From: Kitchen, Robert [mailto:Robert.Kitchen@duke-energy.com]
Sent: Friday, May 29, 2015 11:51 AM
To: Habib, Donald
Cc: Waters, David; Cross-Dial, Andrea
Subject: Reviewer Aid - DCD markup for Levy Condensate Return

Don – Attached is a DCD markup to be used as a reviewer’s aid that reflects an integration of changes to the AP1000 DCD Rev 19 information due to Condensate Return design change that will be incorporated into the Levy COLA. These changes were provided to NRC in the following Duke correspondence:

CONDENSATE RETURN
TIER 1 CHANGES

Figure 3.8.2-1 (Sheet 1 of 3)

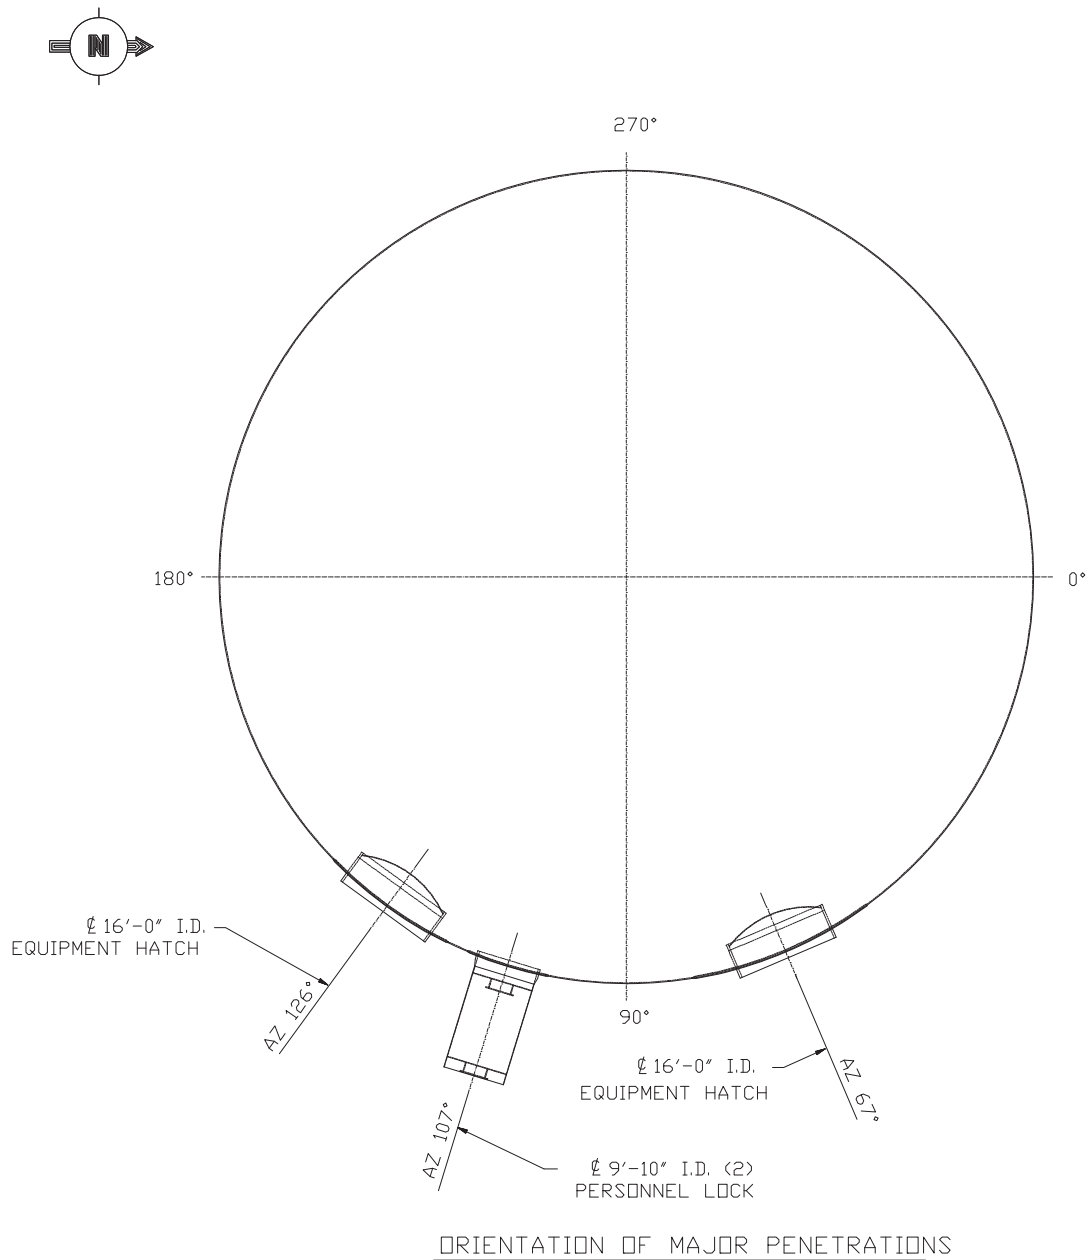
Equipment hatches rotated out of position to show configuration: see Sheet 2 for azimuth orientation.

Shutdown Temperature Evaluation,
 RCS Temperature
 Figure 19E.4.10-201

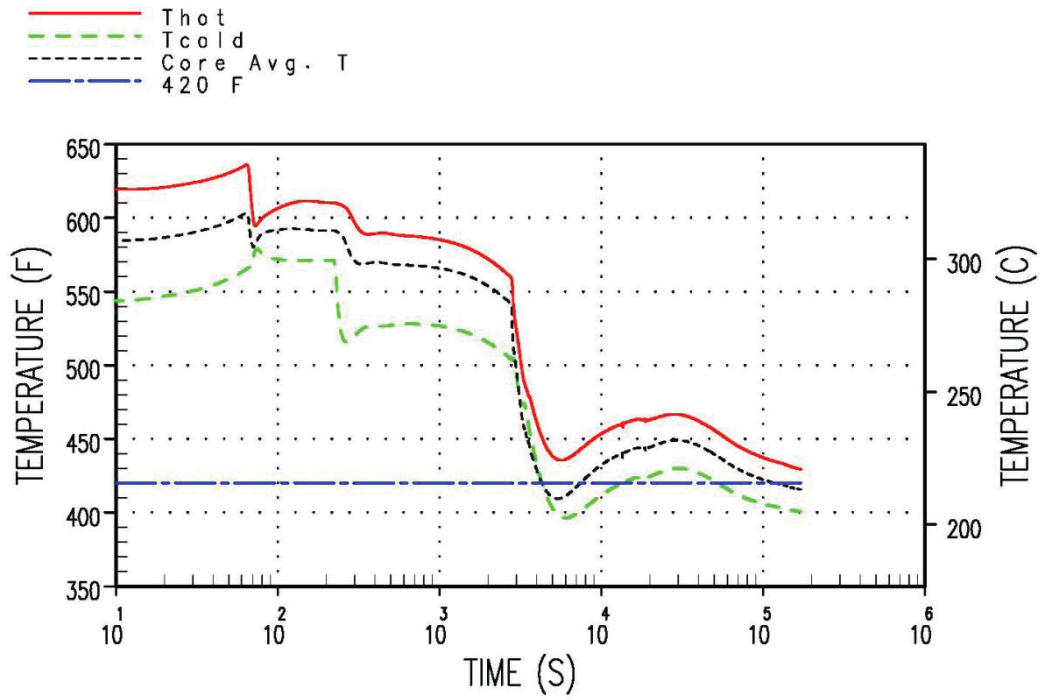
Event CMTs Stop
Circulating has
been deleted

deleted (loop with
PRHR)
